ARCHITECTURAL ADVISORY COMMITTEE  
STAFF MEMORANDUM

DATE: August 11, 2014 NEW BUSINESS

SUBJECT: THE PALM SPRINGS ART MUSEUM REQUESTING APPROVAL OF A SIGN VARIANCE FOR THE MUSEUM'S ARCHITECTURE + DESIGN CENTER (AKA THE SANTA FE FEDERAL SAVINGS & LOAN BUILDING), A CLASS 1 HISTORIC SITE LOCATED AT 300 SOUTH PALM CANYON DRIVE (HSPB 54 / CASE 8.259 VAR, ZONE CBD) (KL).

PARTIAL SITE PLAN - NORTHWEST CORNER

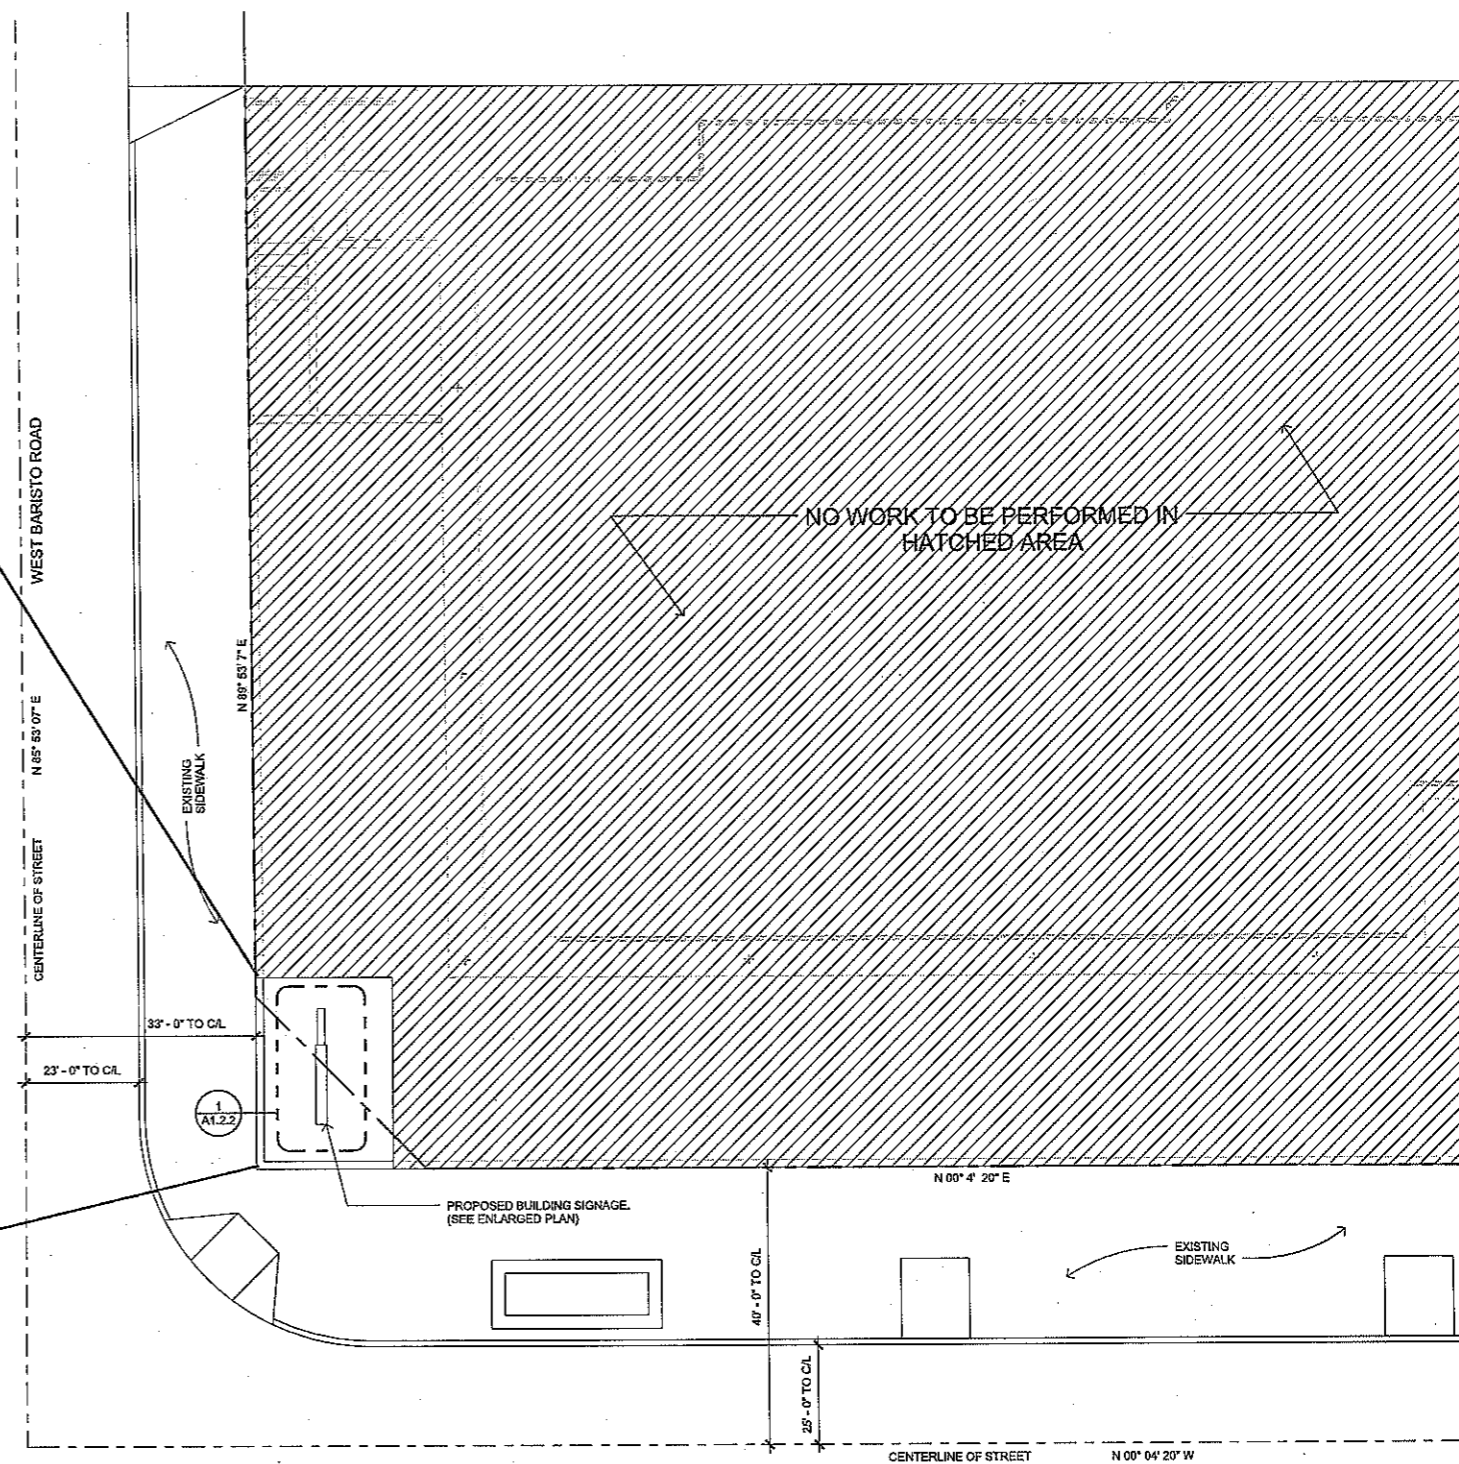
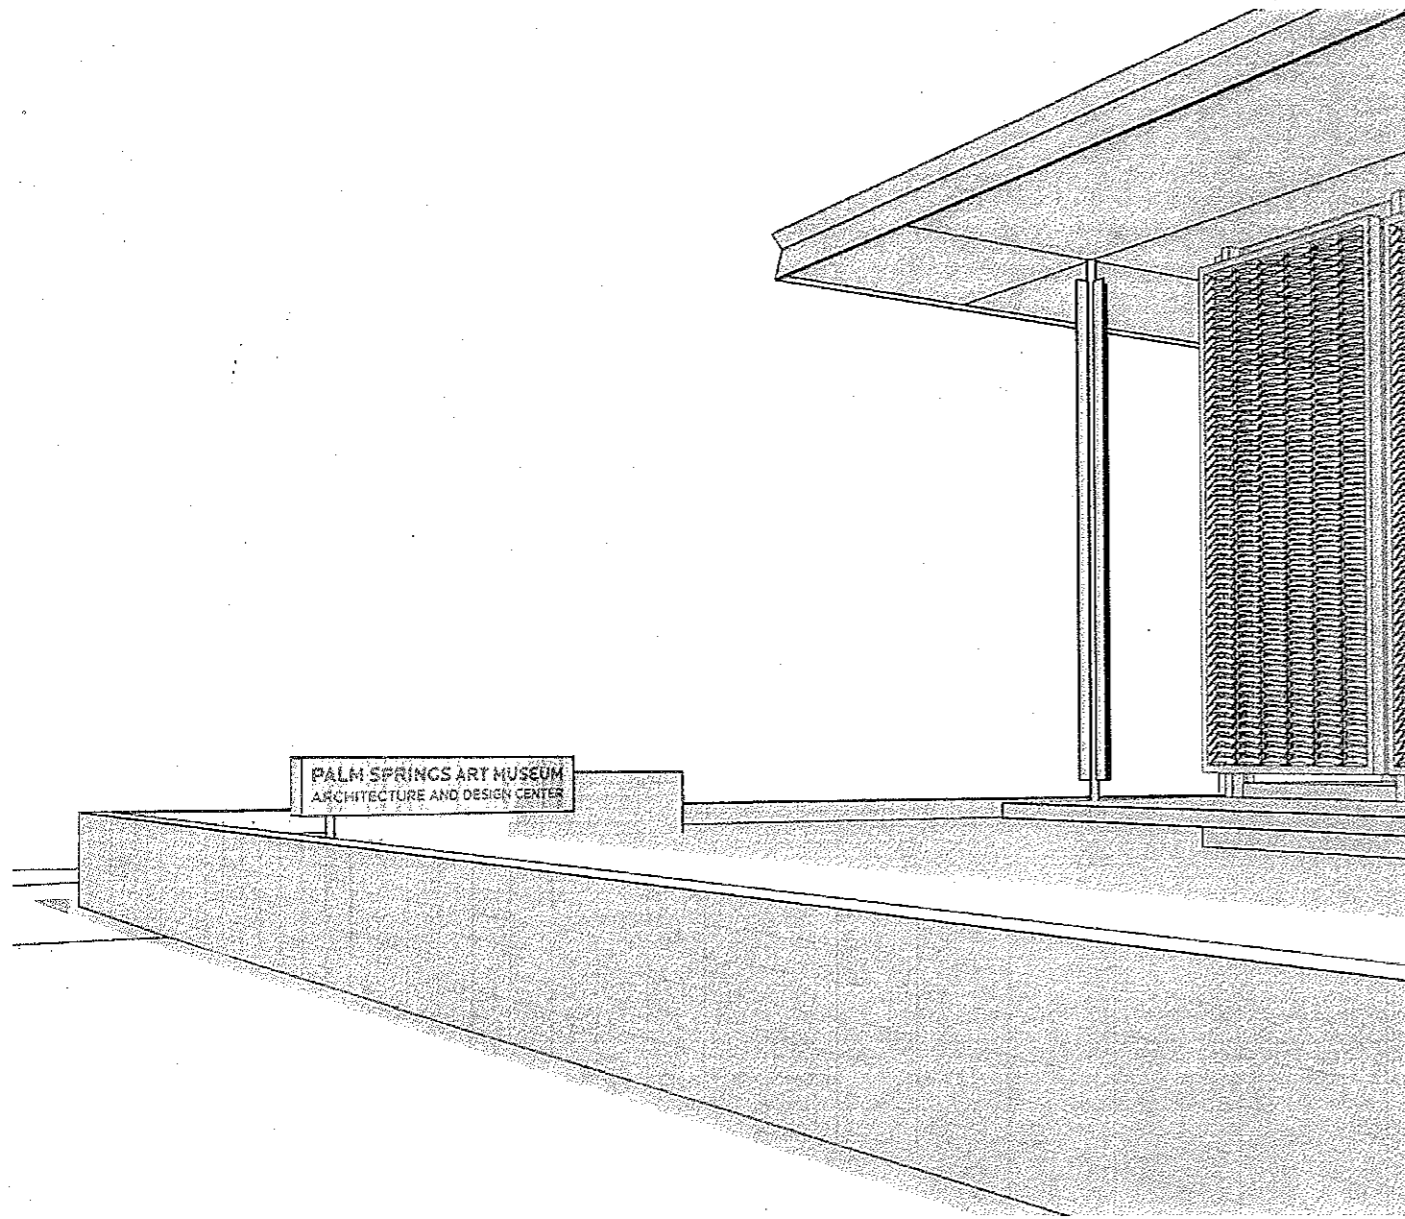
- The proposed sign at the corner of Baristo Road and South Palm Canyon Drive extends into the roadway right of way. An encroachment agreement must be executed between the City and the PSAM prior to installation or permits.

6	Maximum height, area, setbacks and overall mass, as well as parts of any structure (buildings, walls, screens, towers or signs) and effective concealment of all mechanical equipment	No	Monument signs are not a permitted sign type in the CBD. The sign proposed at the northwest corner of the site encroaches into the street right of way and would require execution of an encroachment agreement with the City.
7	Building design, materials and colors to be sympathetic with desert surroundings	Yes	The signs are proposed in neutral tones and subtle materials.
8	Harmony of materials, colors and composition of those elements of a structure, including overhangs, roofs, and substructures which are visible simultaneously	Yes	The proposed signs are harmonious with the existing historic building.
9	Consistency of composition and treatment	Yes	There is consistency in the composition and treatment of the three proposed signs.
